### REMARKS

The amendments to this Patent Application are as follows. An Abstract Of The Disclosure has been added on its own separate page. The Specification has been amended on pages 1, 2, 3, 4, 5, 6, 7, 8, 9, 10, 11, 12 and 16 to include the required section headings and to eliminate reference to the claims. On Page 1 a Cross-Reference To Related Patent Applications has been inserted. On Page 12, a brief description of FIG. 7 has been added. A new revised sheet of drawings for FIGS. 30 and 31 is attached hereto. A Marked-Up Copy of drawings is also enclosed.

**Fig.30****Fig.31**

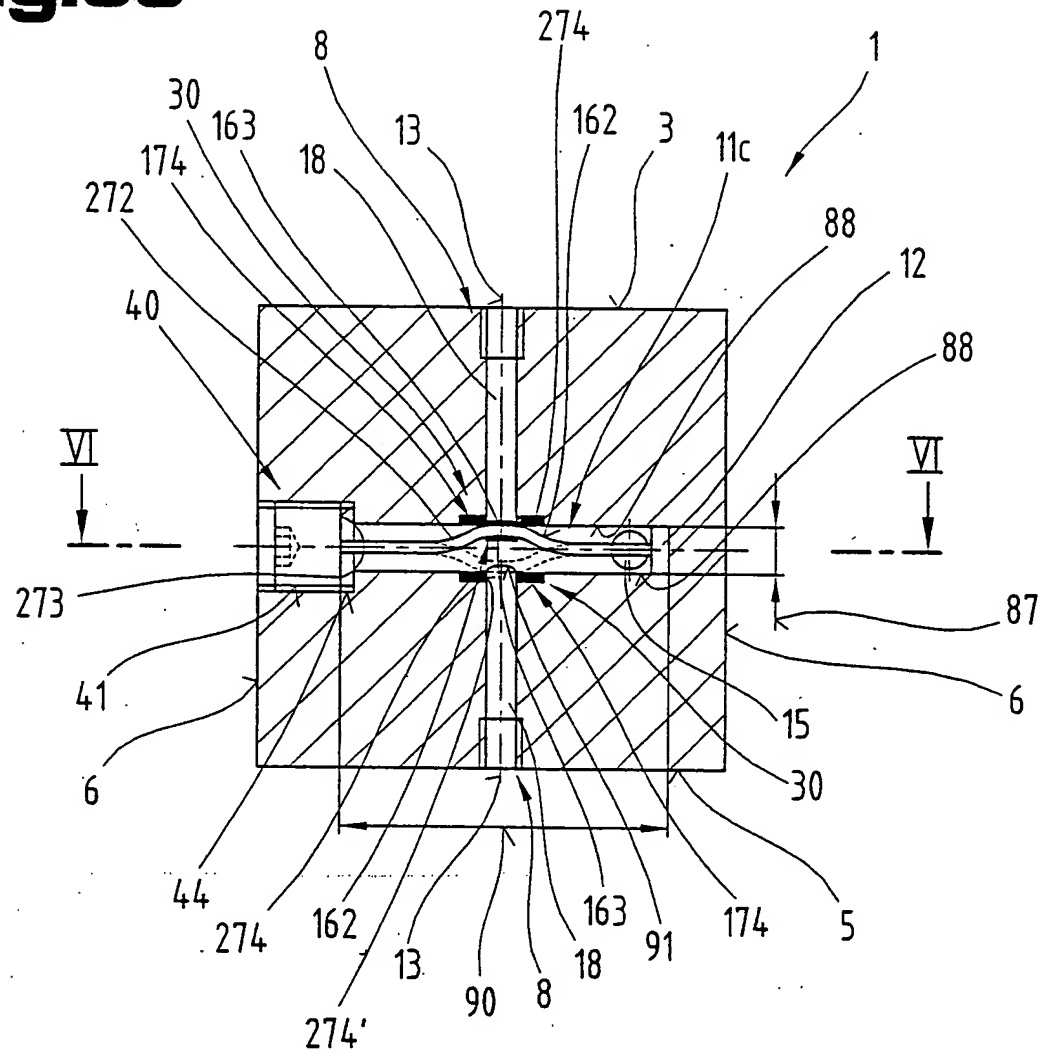
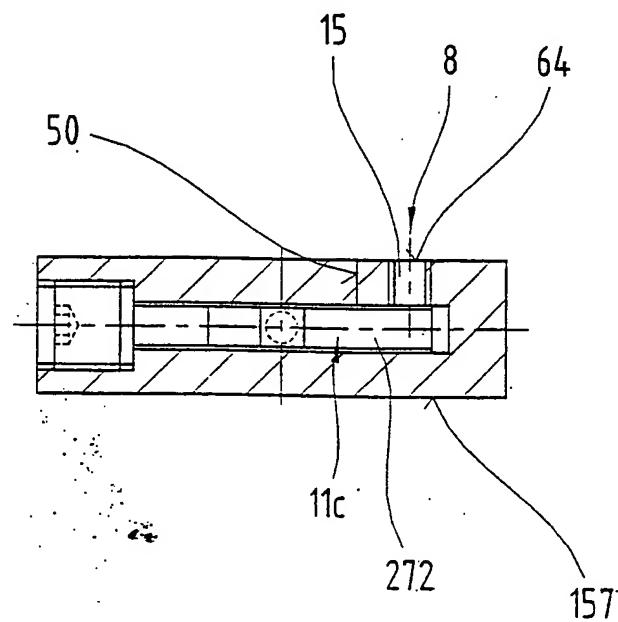
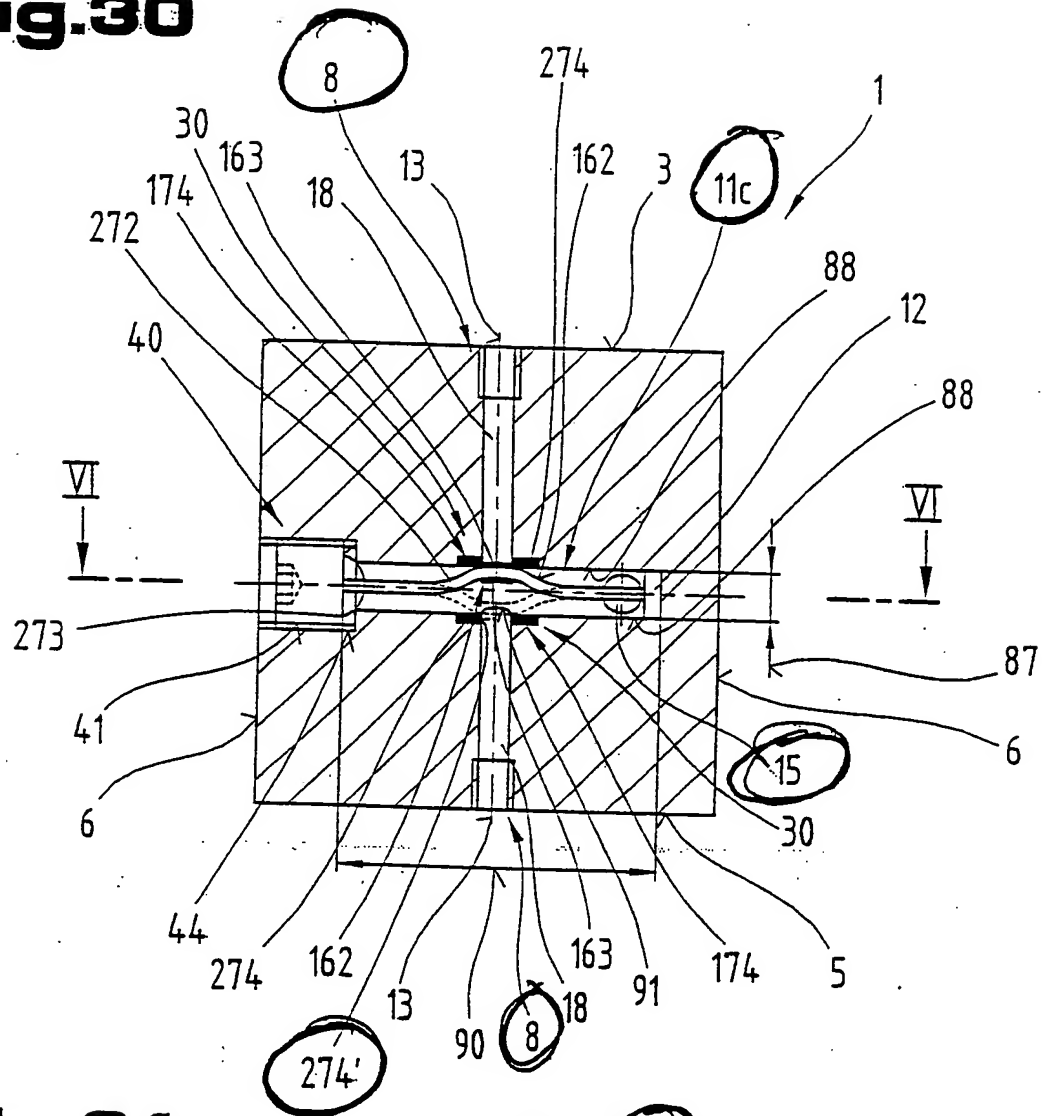
After reviewing FIG. 30 it was noticed that the channel (8) shown in FIG. 31, in particular the flow-through channel (15) is not shown in FIG. 30. Therefore enclosed herewith is a corrected FIG. 30 showing this flow-through channel (15). Also added is the missing reference symbol 274' denoting the opening in the flat coil 274, and reference numeral 163 denoting the sealing layer on the underside of the membrane 272.
